CITY COUNCIL REGULAR MEETING

City Council Chambers, 33 East Broadway Avenue Meridian, Idaho
Tuesday, April 02, 2024 at 6:00 PM

HEARING DATE: 4/2/2024
 TO: Mayor & City Council
 FROM: Sonya Allen, Associate Planner
 208-884-5533
 SUBJECT: SHP-2024-0001
 Watts Meridian Medical Partners
 LOCATION: 1256 S. Rackham Way, in the SW 1/4 of
 Section 16, T.3N., R.1E. (Parcel
 #R6819240215)

STAFF REPORT	
COMMUNITY DEVELOPMENT DEPARTMENT

A. Short Plat (date: 1/11/24)

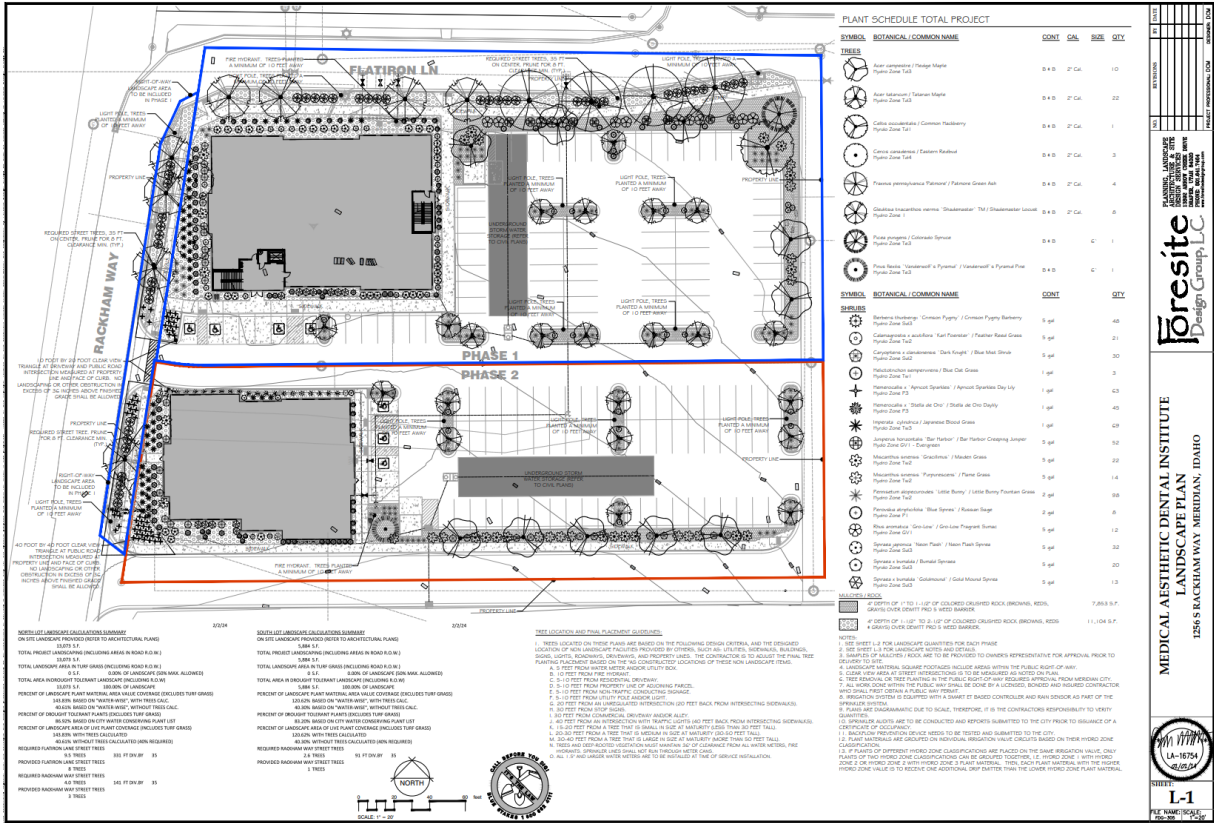
3. The short plat prepared by Focus Engineering and Surveying, LLC on 2/2/2024 by Evan J. Wood, included in Section VI.A, shall be revised as follows:
 - a. Depict pavement widening for Rackham Way and curb, gutter and sidewalk as required by ACHD; additional right-of-way may be required to be dedicated.

B. Landscape Plan (dated: 2/2/24)

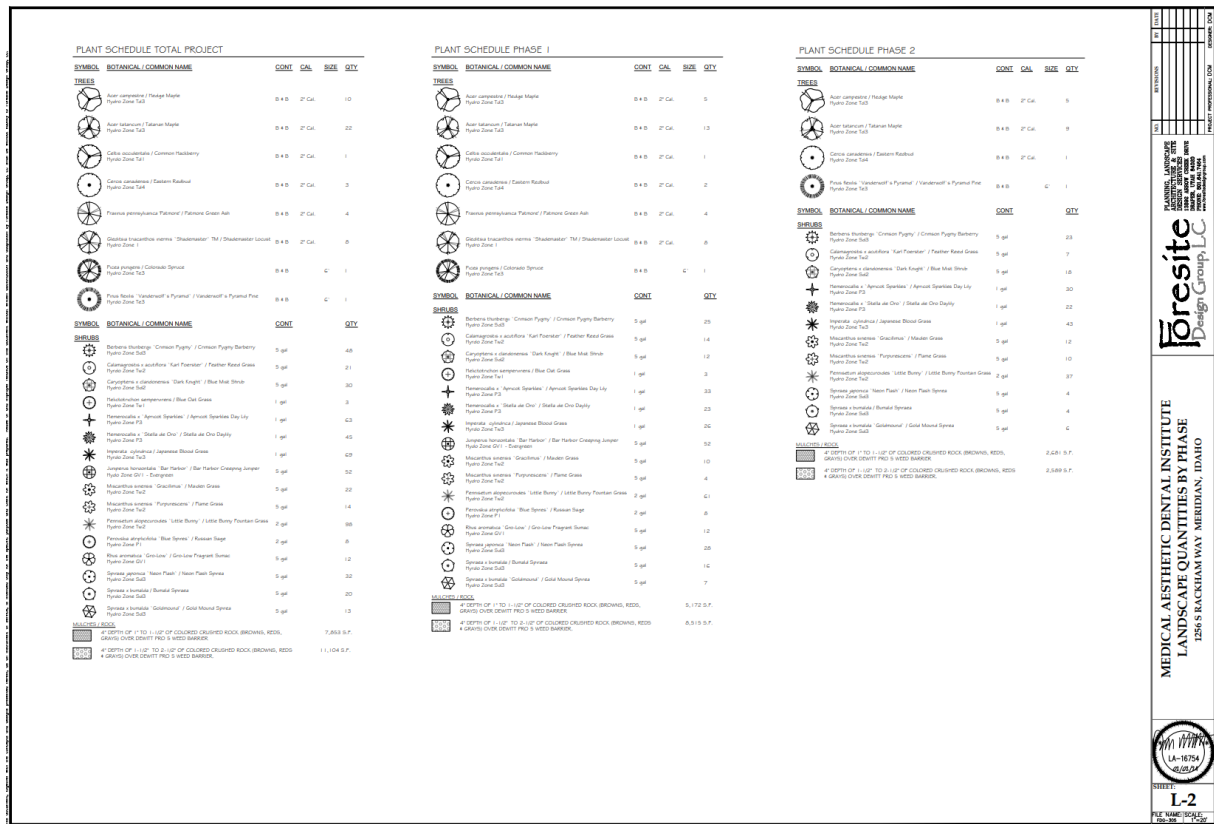
4. The landscape plan prepared by Foresite Design Group shall be revised as follows:
 - a. A minimum 10-foot wide street buffer is required along S. Rackham Way, measured from back of sidewalk if an attached sidewalk is provided, or back of curb if a detached sidewalk is provided, in accord with UDC [11-3B-7C](#). *If additional right-of-way is required for pavement widening of Rackham Way, adjust the location of the buffer accordingly.*

- b. Depict a minimum of seven (7) trees within the street buffer along Rackham Way in accord with the standards set forth in UDC [11-3B-7C](#) (see allowed landscaping in clear vision triangles in UDC [11-3A-3B](#)). *At least 35% of qualifying trees must provide urban canopy at maturity, and at least twenty-five (25) percent of qualifying trees must be Class 2 selections, unless it can be shown that utility conflicts prohibit installation of Class 2 trees.* If trees are not allowed within the existing easements, a minimum 5-foot wide area for planting trees and shrubs shall be provided outside of the easement area as set forth in UDC [11-3B-7C.1b](#).

C. Preliminary Plat (dated: 10/18/23) — NOT APPROVED

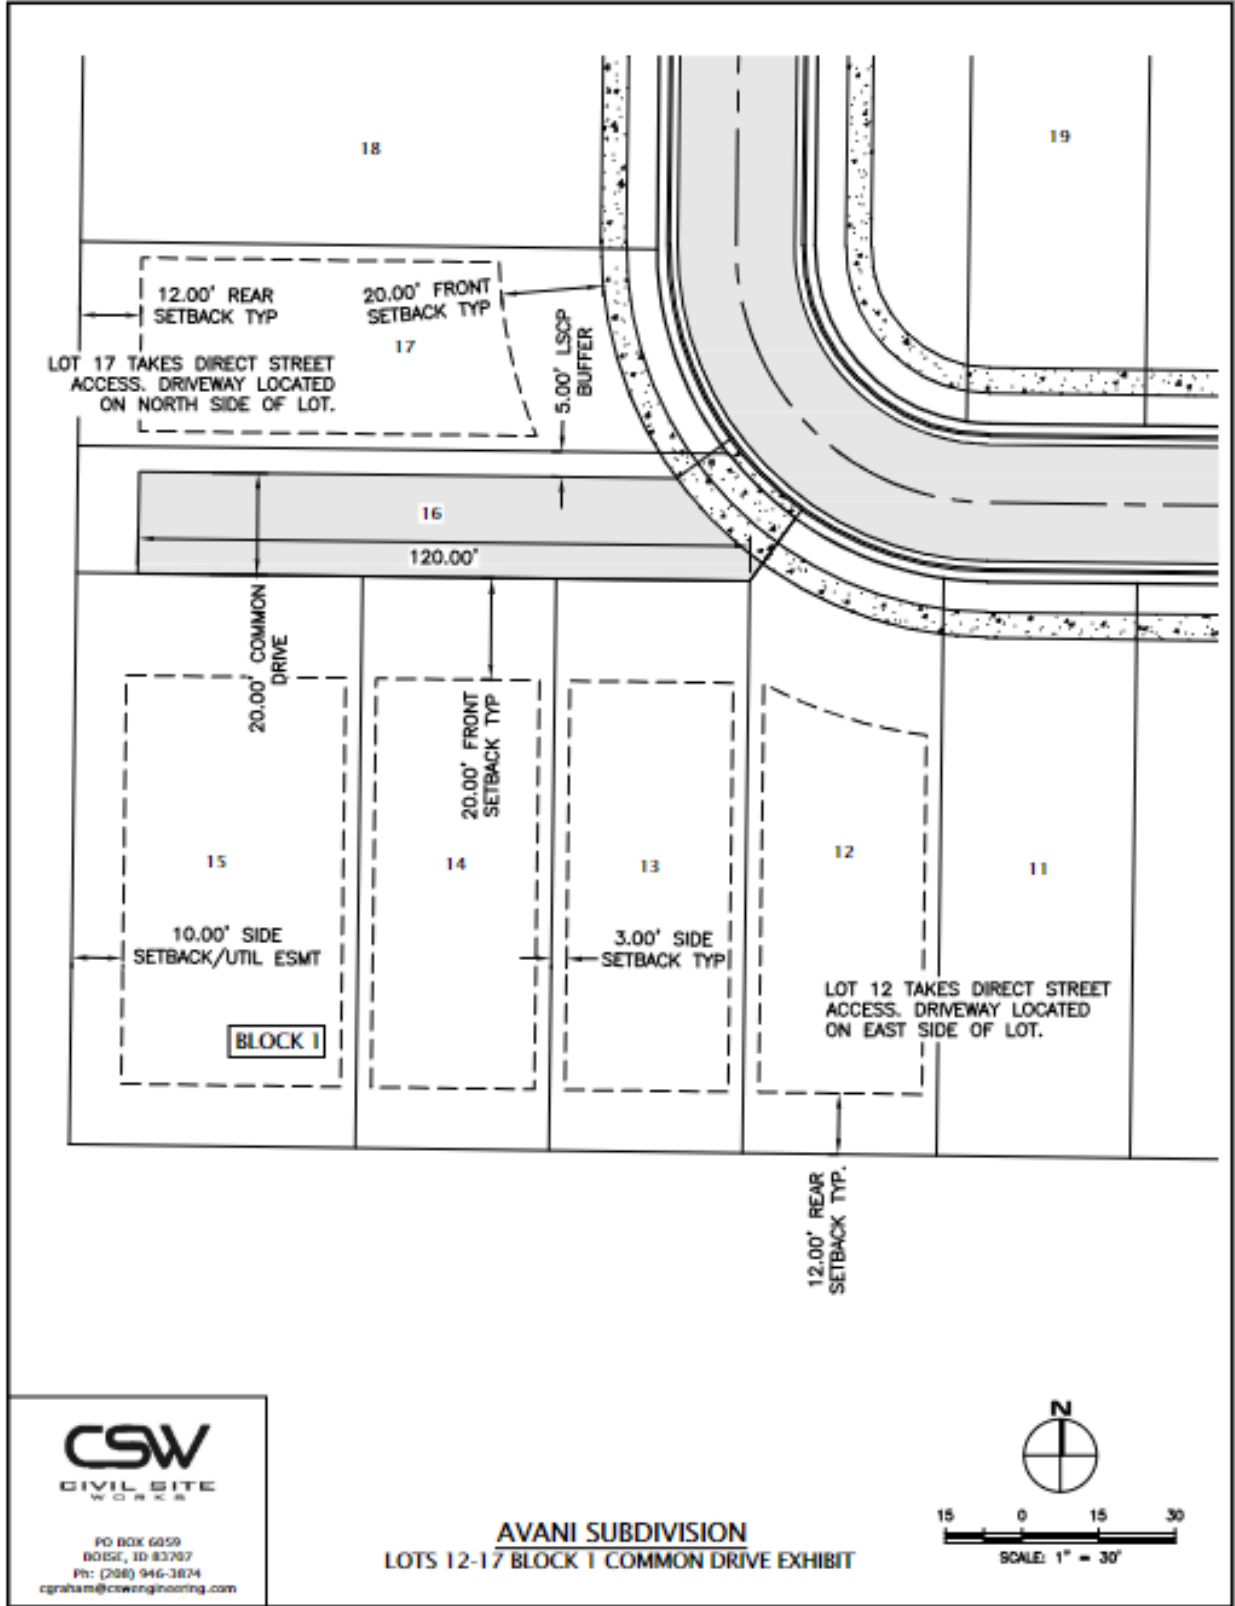
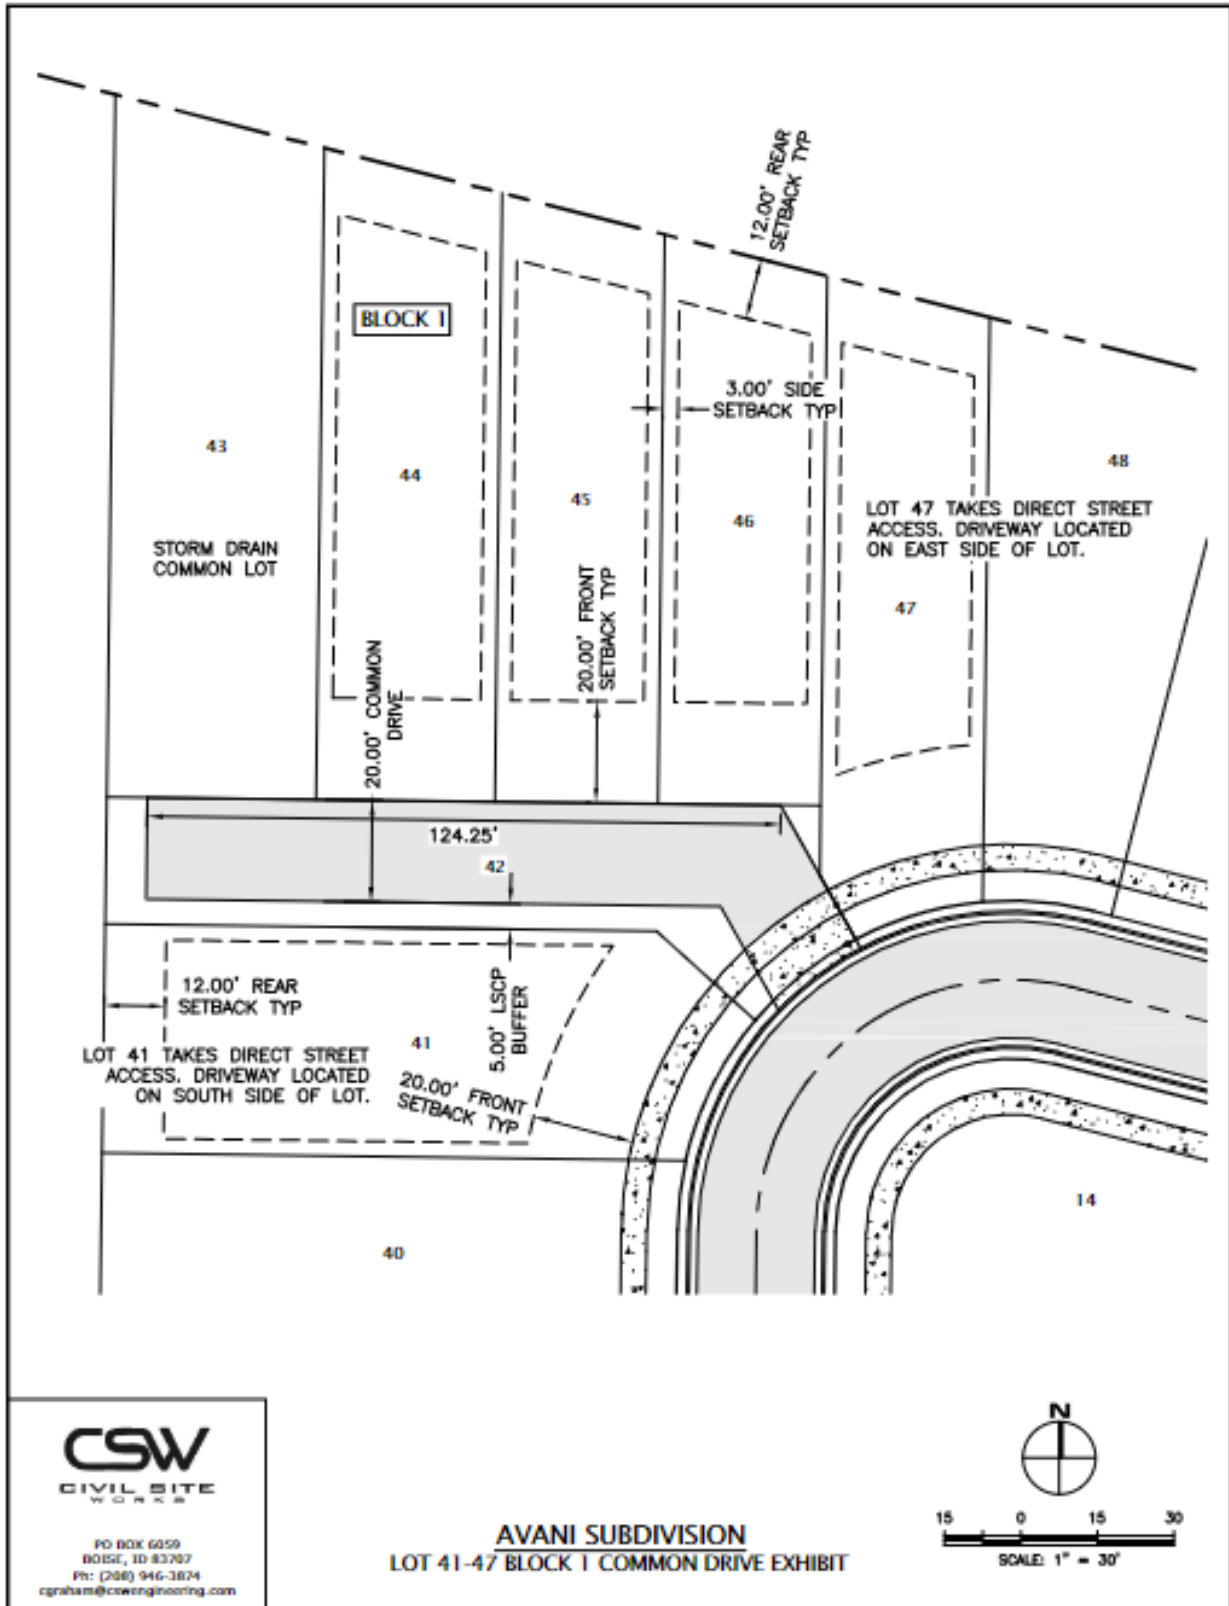
NOTE: Staff is recommending denial of the project because the applicant’s design (plat and elevations) is inconsistent with the design elements outlined in the TMISAP. The applicant has been made aware of Staff’s concerns and has elected to forego some of Staff’s recommended changes to gain a favorable recommendation. Below provides the basis for Staff’s recommendation; however, the Commission and Council should rely on all relevant information when determining if this project is consistent with the Plan and open to allowing deviations from the design elements as desired by the Applicant.

Local streets, alleys, and common drives are proposed internally for access to the proposed residential units. **Staff believes the plat should incorporate more alley-loaded lots however, the Applicant believes there isn’t a market for this type of housing and has elected to limit the number of alley-loaded homes to ten (10) which is inconsistent with the Plan.**

Common Driveway (UDC [11-6C-3D](#)): Six (6) common driveways are proposed within the development of the site on Lot 42, Block 1, Lot 16, Block 1, Lot 41, Block 2, Lot 33, Block 2, Lot 16, Block, 2, and Lot 23, Block 5. Common driveways are allowed to serve a maximum of four (4) dwelling units; in no case shall more than three (3) dwelling units be located on one (1) side of the driveway. **A total of four (4) dwelling units are proposed on the south side of driveway for Lot 23, Block 5; the final plat and common driveway exhibit shall be revised to depict a maximum of three (3) units on one (1) side of the driveway as required; or, alternative compliance may be requested as set forth in UDC [11-5B-5](#).**

2. The final plat shall include the following revisions:
 - a. Include a note prohibiting direct access via S. Black Cat Road and Vanguard Way.
 - b. Depict street sections for Vanguard Way consistent with Street Section C in the TMISAP with a modification that allows (3) 11-foot travel lanes, 8-foot parkways and detached 10-foot wide sidewalks/pathways in lieu of on-street bike lanes as required by ACHD. Streetlights are required at a pedestrian scale, unless another alternative is approved (see pg. 3-20, 3-22, 3-23).
